HISTORIC PRESERVATION COMMISSION

SUBJECT: Historic Area Work Permit # 867436 REVISION #4: Basement Areaway and Entrance,
Porch Flooring, and Door Revisions.

Applicant: 19501 Georgia LLC (Luke Olson, Agent)
Address: 19 High St. (Parcel 700), Brookeville

**19 HIGH ST
LOT 4**

FILE NAME: 5 4 3 2 1

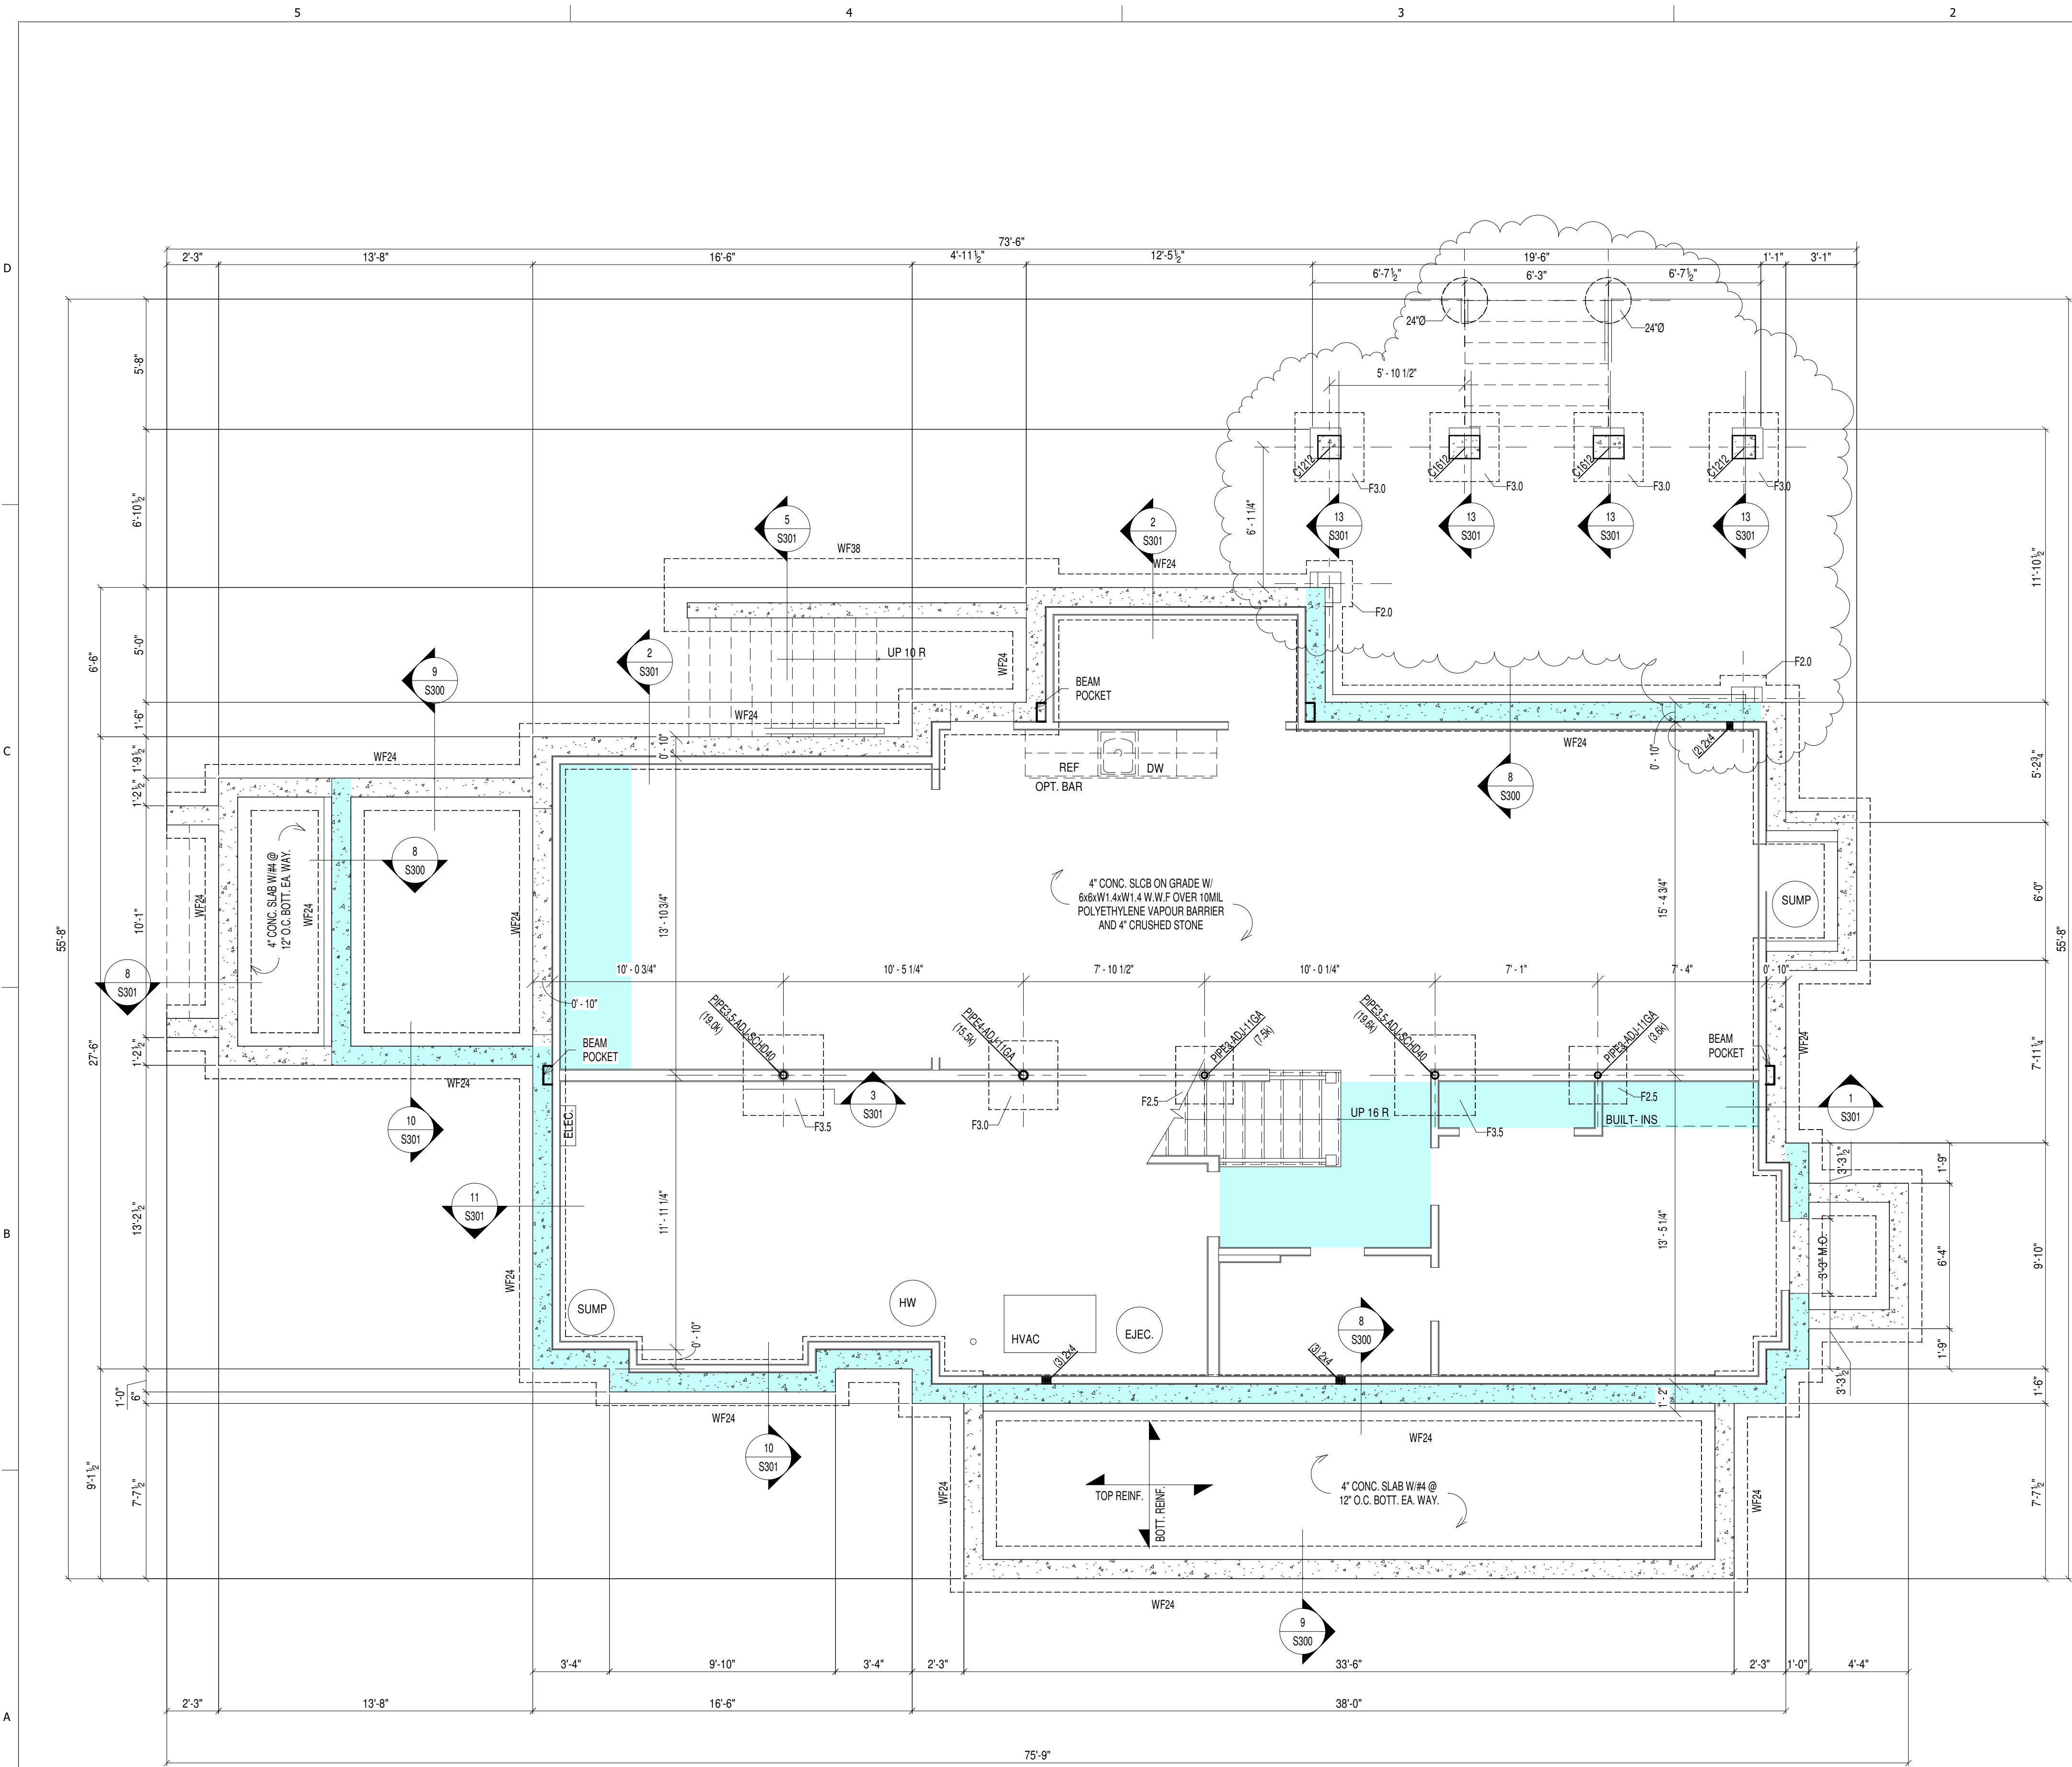
ATTACHED DECK FLASHING DETAIL
Figure 15
